EPA Superfund
Explanation of Significant Difference for the Record of Decision:

South Municipal Water Well Supply
Peterborough, NH
2/3/1997

DECLARATION FOR THE EXPLANATION OF SIGNIFICANT DIFFERENCES

RESPONSIVENESSS SUMMARY FOR THE EXPLANATION OF SIGNIFICANT DIFFERENCES FOR THE SOUTH MUNICIPAL WATER SUPPLY WELL SUPERFUND SITE
February 3, 1997

Figure 1

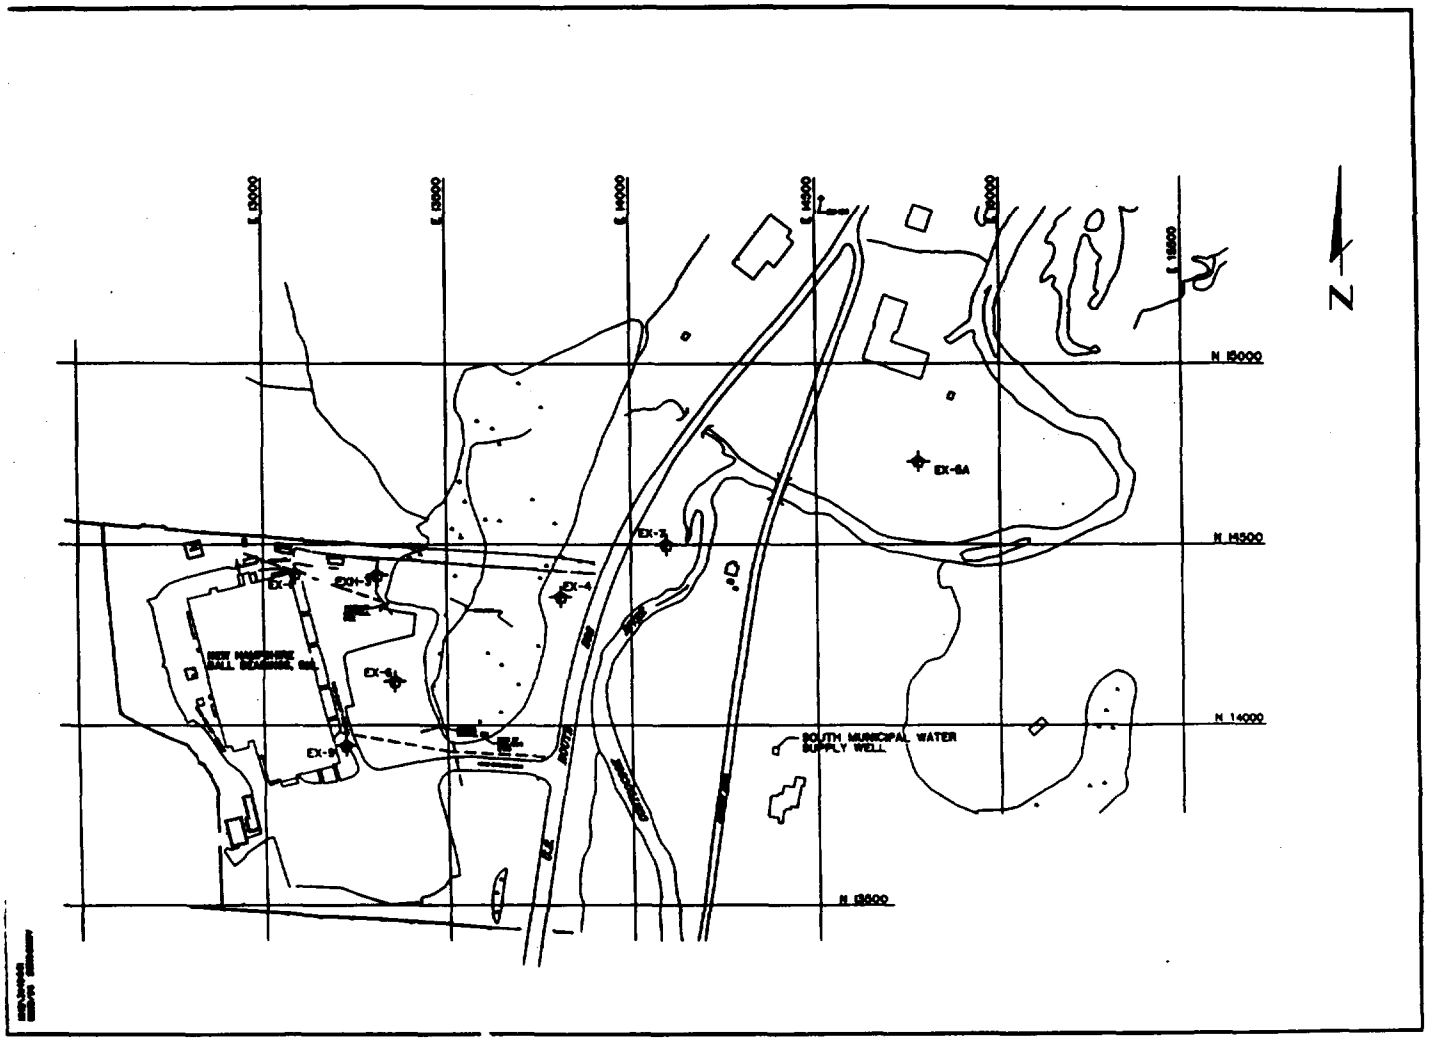
2. Comment: NHBB notes that the discussion of the "NHBB plume area" and the "dilute plume area" causes confusion since the TI Waiver area overlaps a portion of the dilute plume area. The TI Evaluation indicates that the dilute plume area can be fully restored, however.

Response: EPA acknowledges the confusion and has modified the text in the ESD and in the TI Evaluation and included the "Figure 1" provided by NHBB which eliminates the plume designations.

FIGURE 2

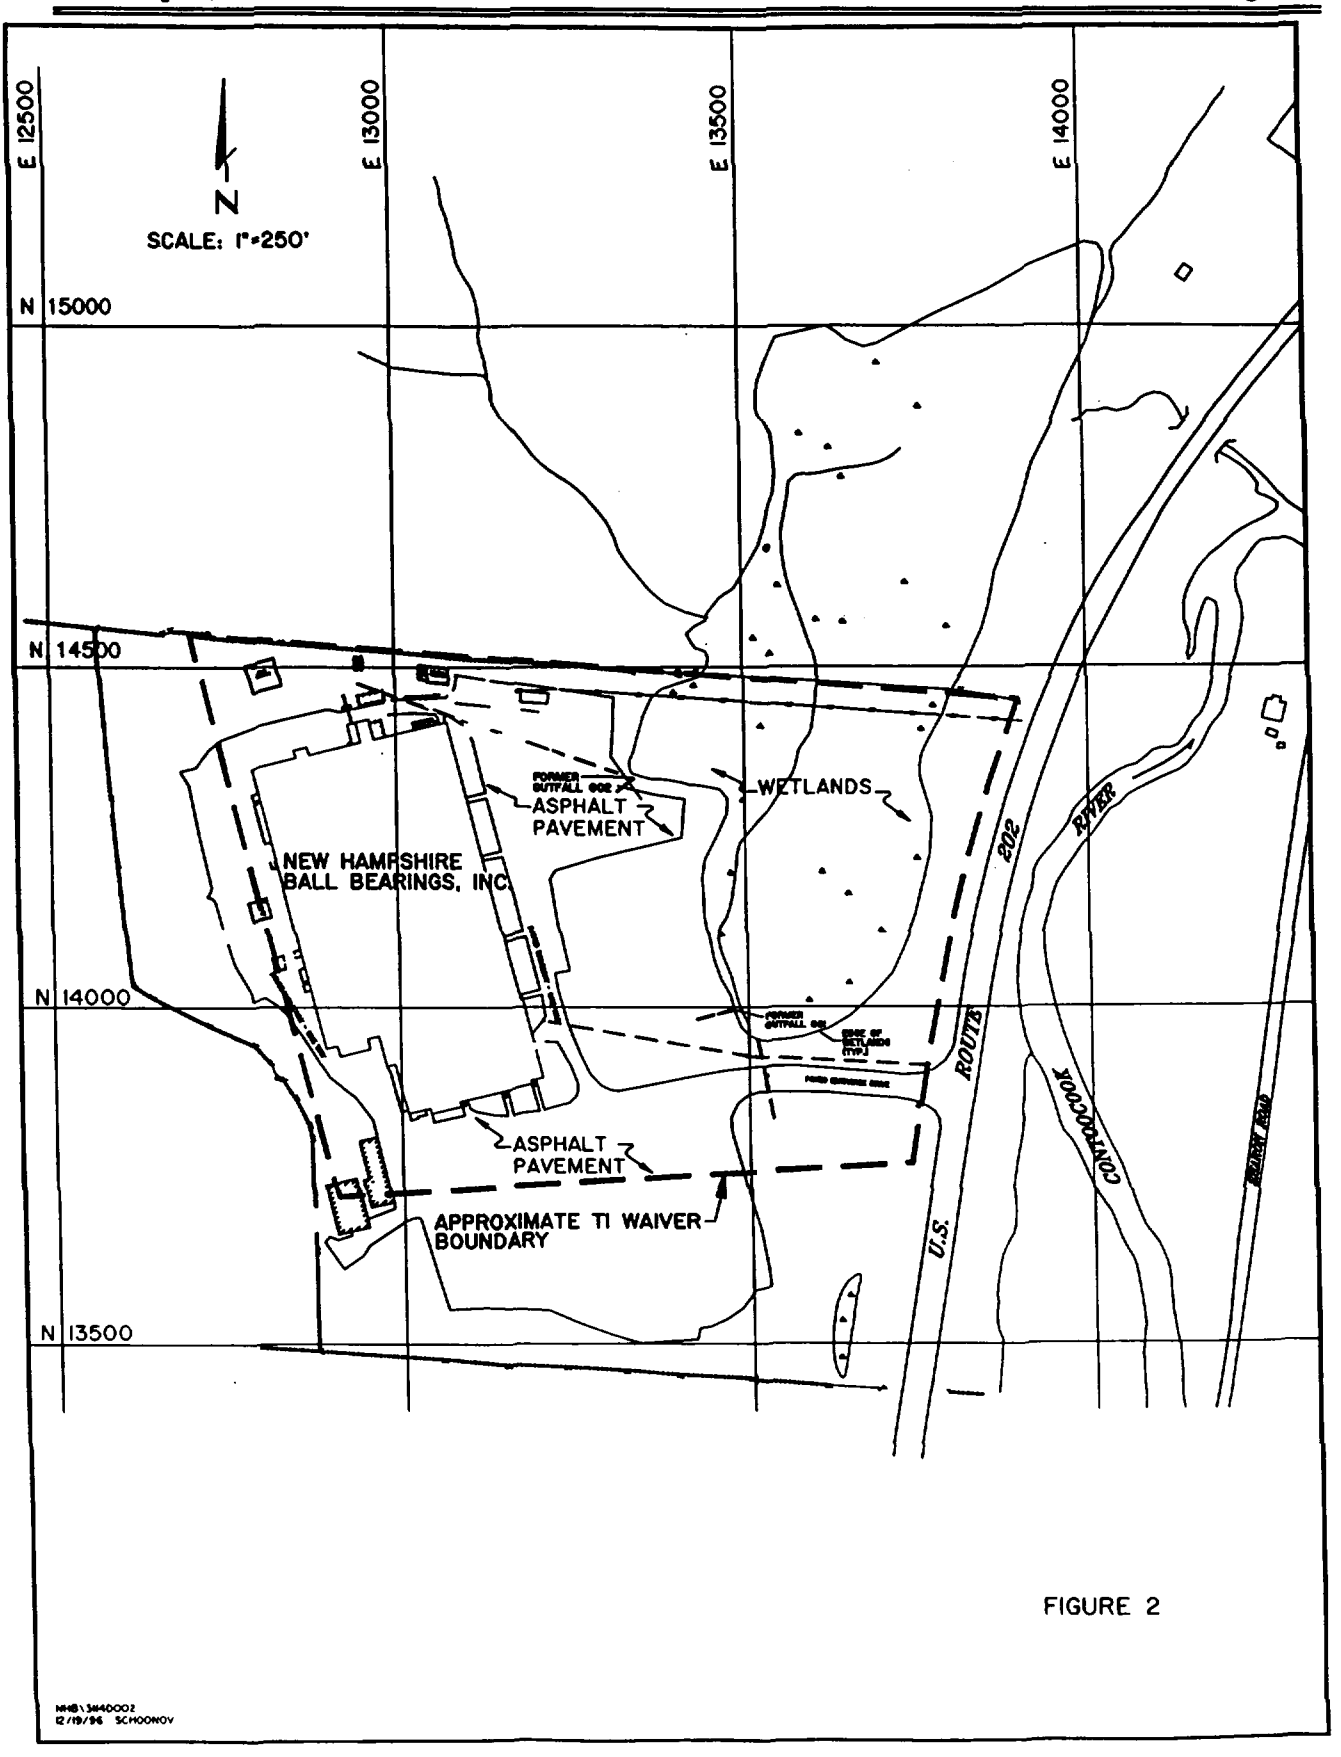
1. Comment: NHBB pointed out that the eastern boundary of the TI Waiver area should extend to the eastern limit of the property (Lot 22 of the Peterborough R-3 Tax Map) controlled by NHBB. This would place the eastern boundary fifty feet to the west of the centerline of Route 202.

Response: This was EPA's intent. EPA has adjusted the boundary in the ESD and TI evaluation.
